CONSTRUCTION CHANGE ORDER

PROJECT: Sessom Creek Bank Stabilization and WW Replacement - Phase 2
CONTRACT NO.: 224-002

Date Prepared: 9/5/2025
Change Order #: 4

Re: Sessom Creek Bank Stabilization & Wastewater Replacement – CO #4

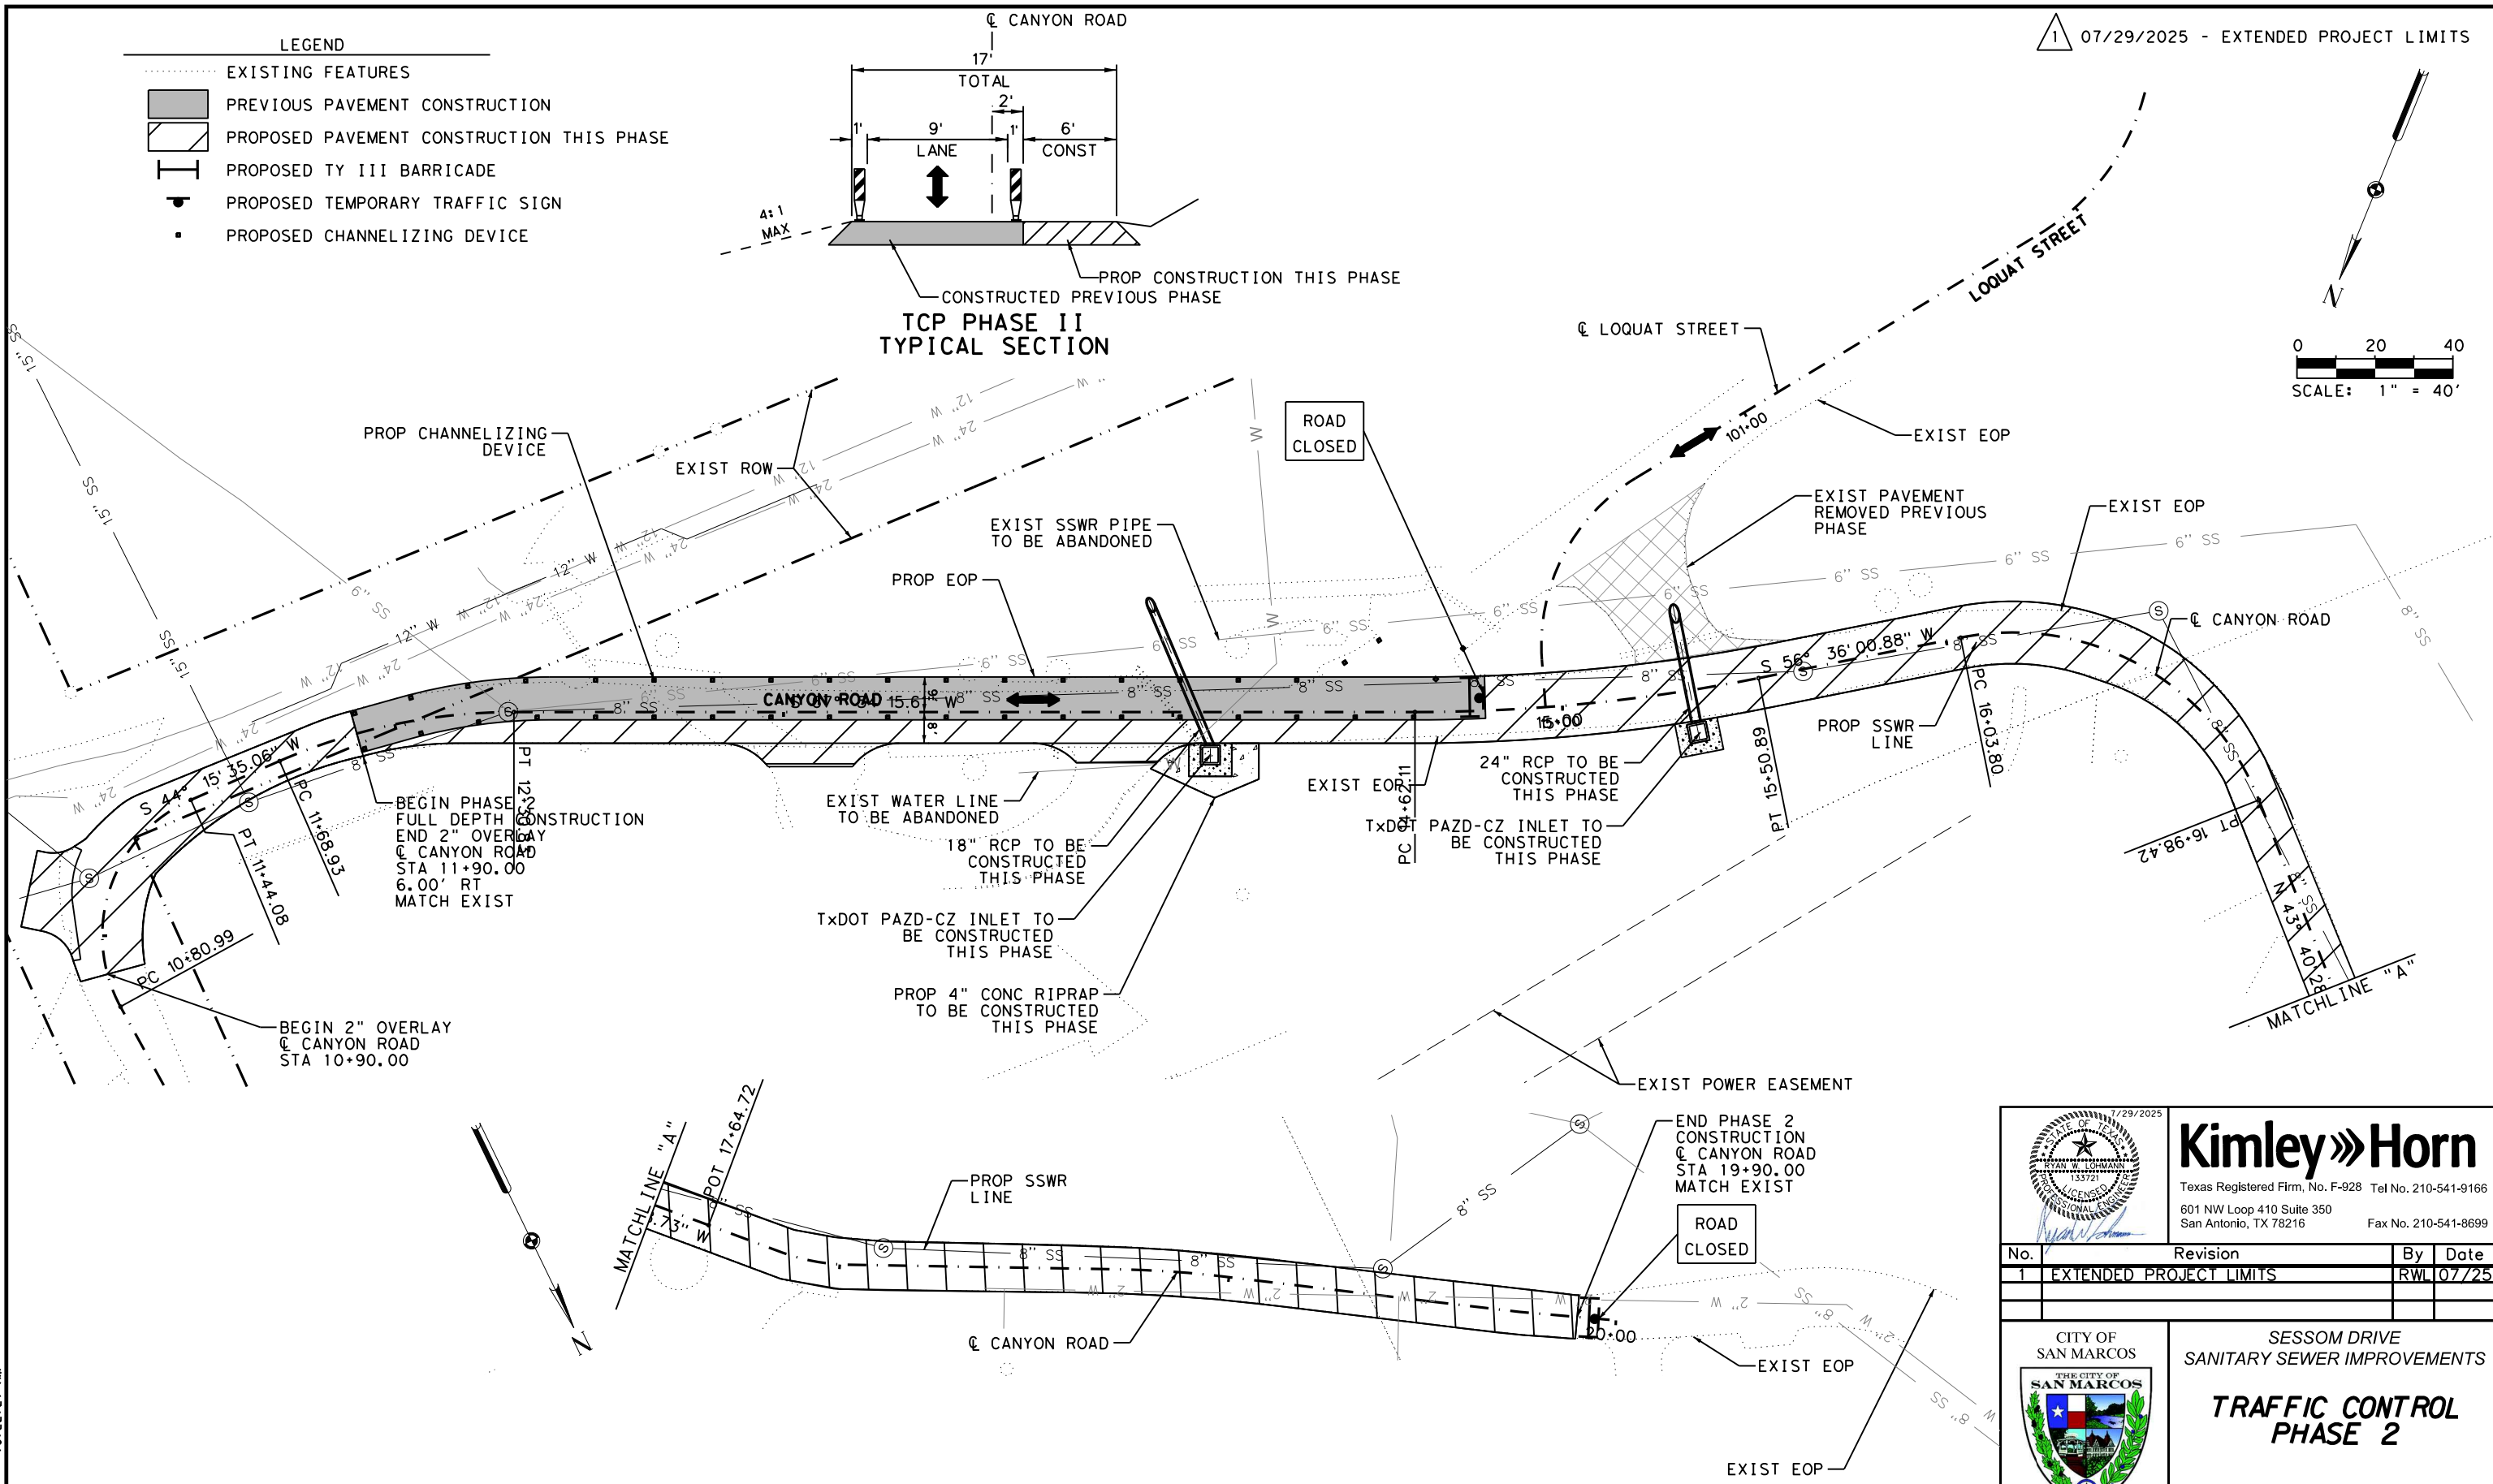
Corresponding quantity adjustments per RFI 14a:
Additional WW Replacement = Remove exposed wastewater line upstream of MH 17 and replace with new WW line & appurtenances
Additional Roadway Repair = Full road repair up to the concrete driveway of 107 Canyon Rd to better coincide with limits of W/WW replacement
Revised water services = 1" blue poly (in lieu of 2" PVC) per COSM Public Works preference
Revised tree protection (additional tree removal & corresponding mitigation measures), erosion control, and quantity sheets to correspond with the plan revisions noted above
Add 40 Working Days (approx. 2 months) to the Project Schedule (PS-1):
> The Contractor must achieve Substantial Completion within **250 Working Days** after the Project Start Date = Wednesday, May 6, 2026
> The Contractor must achieve Final Completion within **295 Working Days** after the Project Start Date = Monday, July 13, 2026

SESSOM DRIVE
SANITARY SEWER IMPROVEMENTS
PLAN AND PROFILE
CANYON ROAD

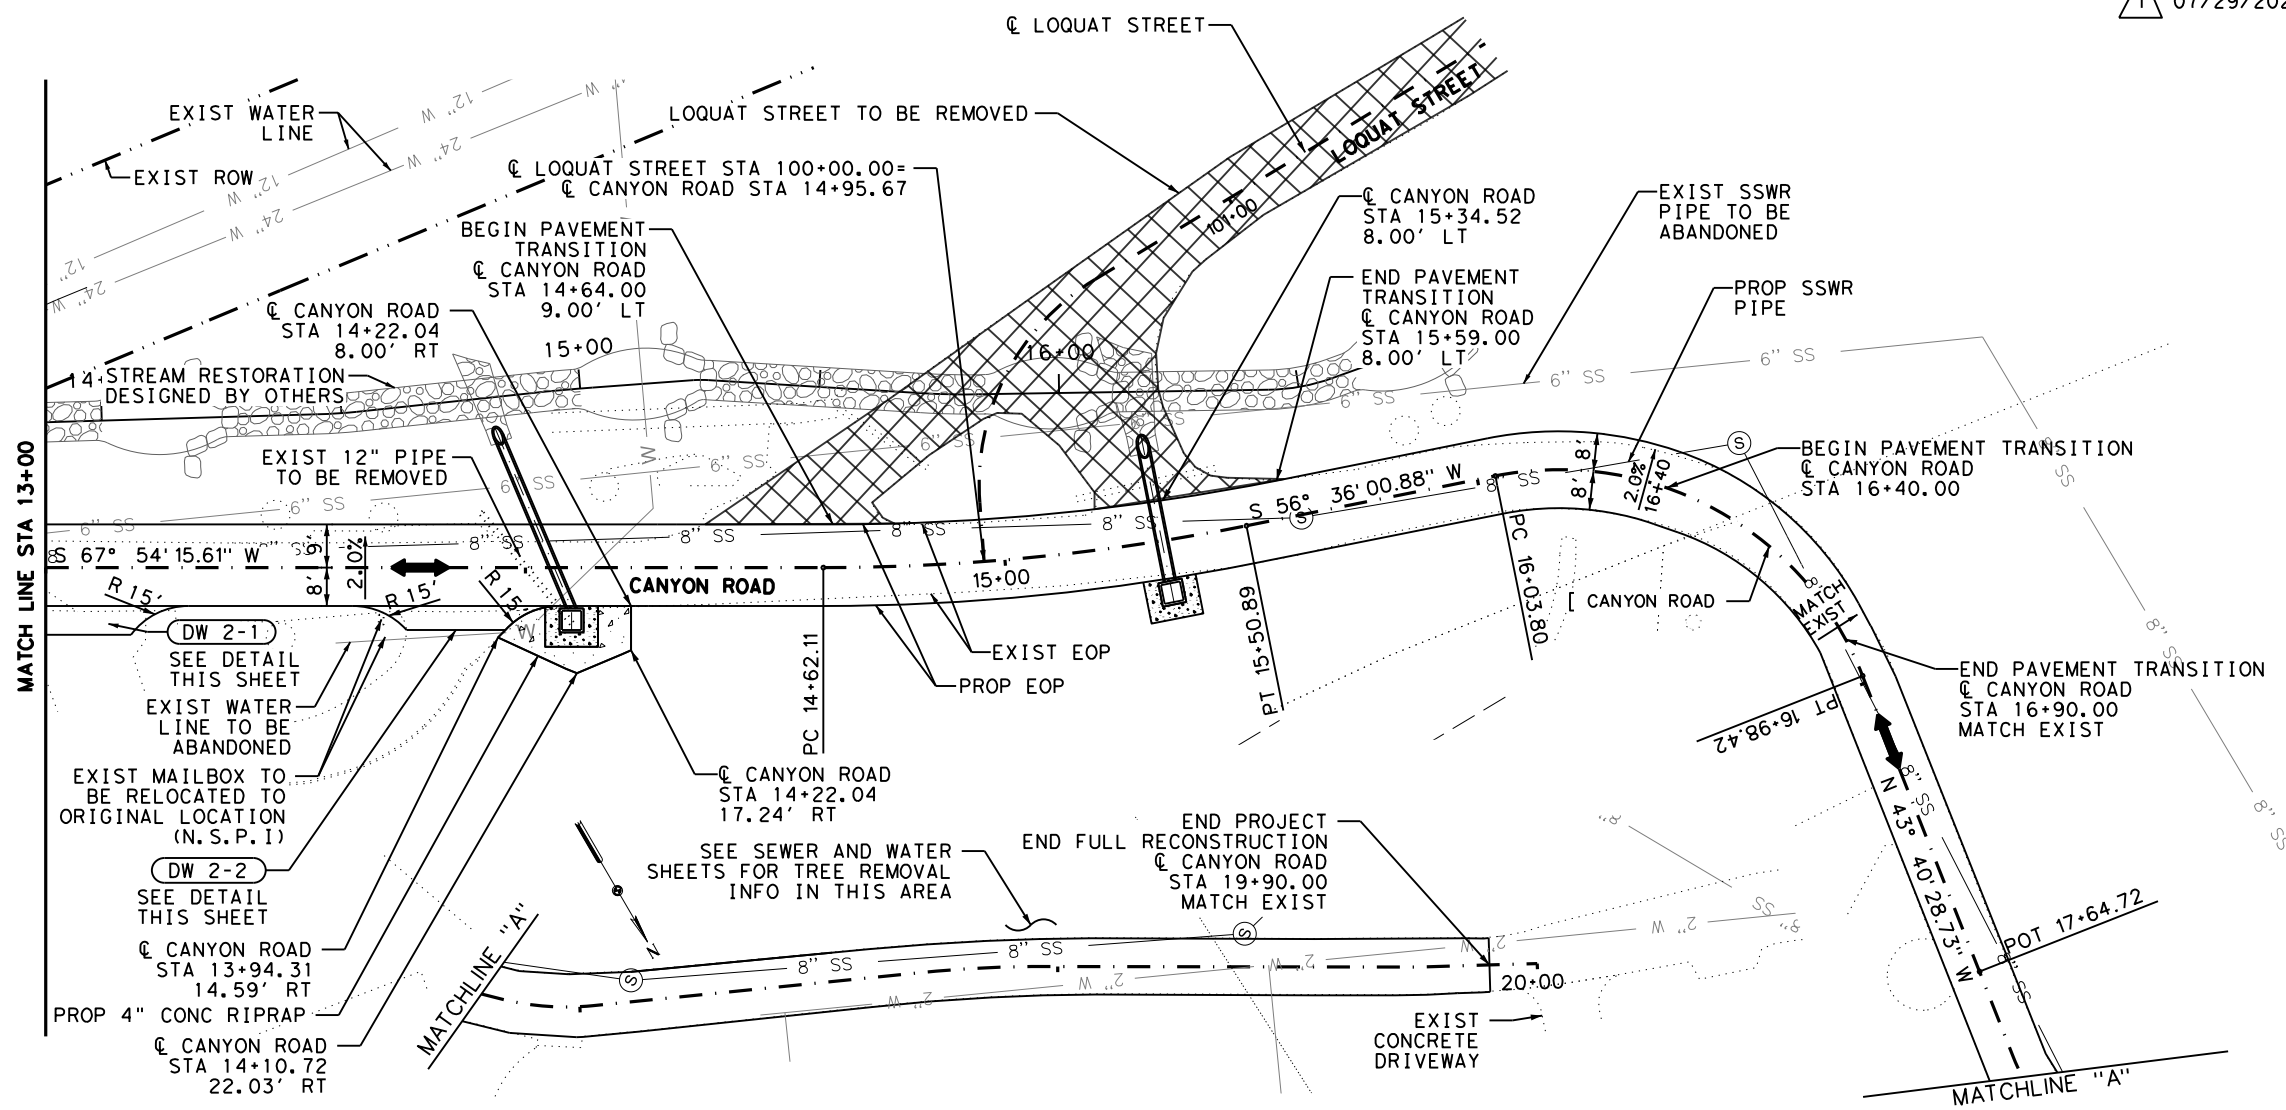
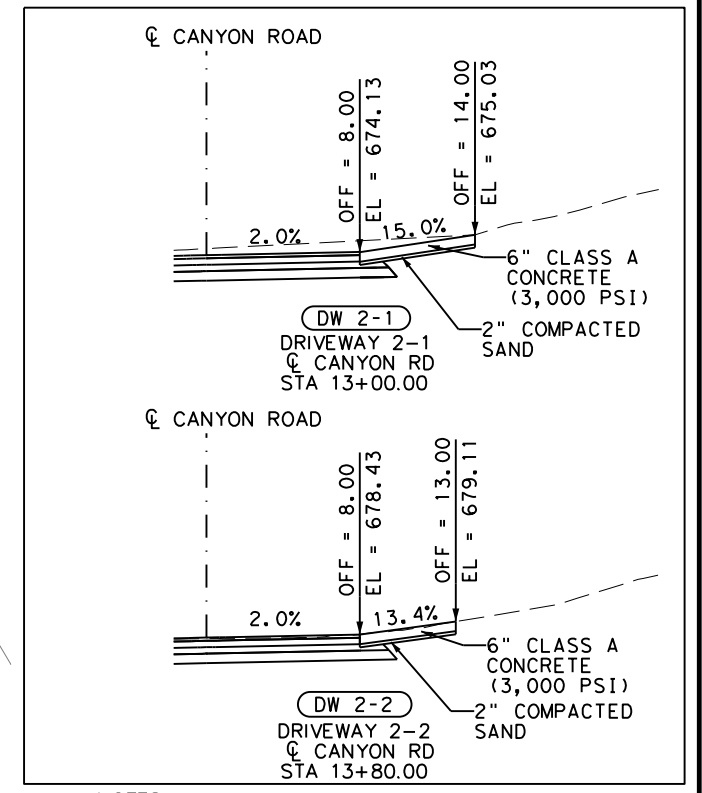
- NOTES:
1. CONTRACTOR TO COORDINATE WITH PROPERTY OWNER 2 WEEKS PRIOR TO CONSTRUCTION OF DRIVEWAYS
 2. UTILITY LOCATIONS SHOWN ARE APPROXIMATE. CONTRACTOR TO VERIFY LOCATIONS PRIOR TO CONSTRUCTION
 3. CONTRACTOR TO MATCH PROFILE, CROSS SLOPE AND PAVEMENT WIDTH FOR ROADWAY CONSTRUCTION FROM STA 16+90.00 TO 19+90.00
